Access Compliance Report
Public Rights-of-Way
(Curb Ramps)

Intersection ID: 49346 **Main Street:** BLUE_JUNCTION_RD **Cross Street:** FIRESPIKE_RD **Location:** NW

ADA ID: 47317BB32A25 **Ramp Type:** Perp **Initial Pass/Fail:** Pass **Overall Compliance:** No **Severity Score:** 5

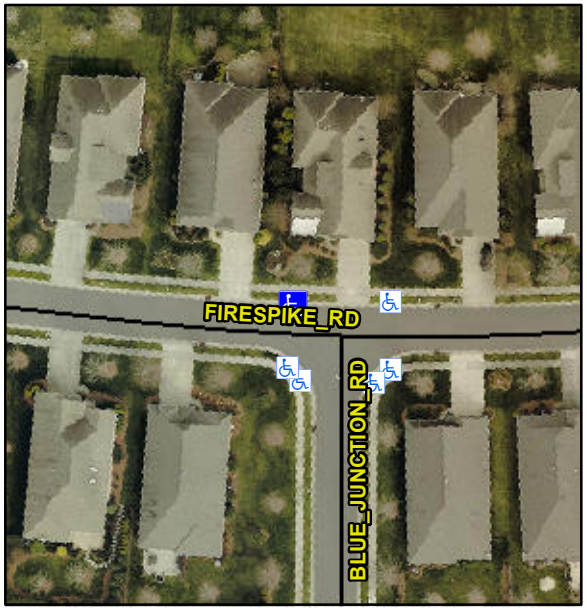
Not Found, R304.5.4

Compliance	Description	Data	Compliance	Description	Data
N/A	Ramp Length (in)	48.0	Yes	Ramp Slope (%)	7.6
Yes	Ramp Width (in)	48.0	Yes	Ramp XSlope (%)	0.9
N/A	Flare Type LT	Sloped	N/A	Flare Type RT	N/A
N/A	Flare Slope LT (%)	3.3	N/A	Flare Slope RT (%)	4.9
N/A	Flare Traversable LT?	No	N/A	Flare Traversable RT?	No
Yes	Landing Length (in)	48.0	Yes	DWS Provided?	Yes
Yes	Landing Width (in)	48.0	Yes	DWS Contrast?	Yes
Yes	Landing Slope (%)	0.3	Yes	DWS Length (in)	25.5
Yes	Landing X Slope (%)	1.2	Yes	DWS Full Width?	Yes
N/A	Landing Curb? (Y/N)	No	Yes	DWS Offset (in)	0.0
N/A	Shared Landing?	No			
Yes	Gutter Ponding?	No	No	Gutter Slope (%)	6.0
Yes	Gutter Lip Ht (in)	0.0	Yes	Gutter X Slope (%)	0.8
N/A	Painted X Walk1?	No	N/A	Painted X Walk2?	N/A
	X Walk 1 Direction	To SW		X Walk 2 Direction	N/A
N/A	X Walk 1 Width (in)	N/A	N/A	X Walk 2 Width (in)	N/A
	X Walk 1 Slope (%)	2.8		X Walk 2 Slope (%)	N/A
	X Walk 1 X Slope (%)	0.6		X Walk 2 X Slope (%)	N/A

Remove & Replace Entire Ramp.
Remove & Replace Gutter.
